**CITY OF SAINT PAUL
HERITAGE PRESERVATION COMMISSION STAFF REPORT**

FILE NAME: 855 West Seventh Street
HISTORIC NAME: Stahlmann-Schmidt-Bremer House
DATE OF APPLICATION: June 17, 2019
APPLICANT: Lois Mueller, RS EDEN
OWNER: RS EDEN
PROJECT MANAGER: Andy Goke, Apadana Solar Technologies
DATE OF HPC MEETING: July 15, 2019
PIN: 122823230054
HPC SITE/DISTRICT: Jacob Schmidt Brewing Company Heritage Preservation District
CATEGORY: Contributing
INVENTORY NUMBER: RA-SPC-5316
PERIOD OF SIGNIFICANCE: 1858-1955
NRHP: Jacob Schmidt Brewing Company Historic District (2018) RA-SPC-5318
CLASSIFICATION: Building Permit
ZONING: RM2 **WARD:** 2 **PLANNING DISTRICT:** 9
STAFF INVESTIGATION AND REPORT: Christine Boulware
DATE: July 2, 2019

Project Address:
855 West Seventh St

Solar System Details

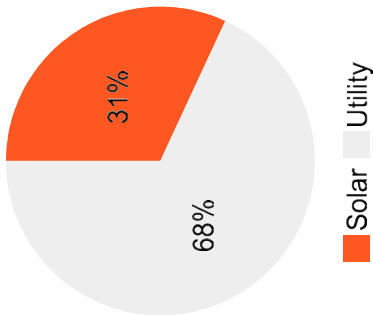
Sec.74.08(b)(4) d. Chimneys, stovepipes and smokestacks: Chimneys and smokestacks should be preserved or	Yes	The "Solar System Details" sheet shows the chimneys unaffected by the potential installation.

10. The "Solar System Details" sheet shows the chimneys unaffected by the potential installation.
11. The installation of the solar panels will not remove nor alter architectural features that give the roof its character and will not adversely impact the historic massing, proportions, scale and design of the architectural elements of the roof.
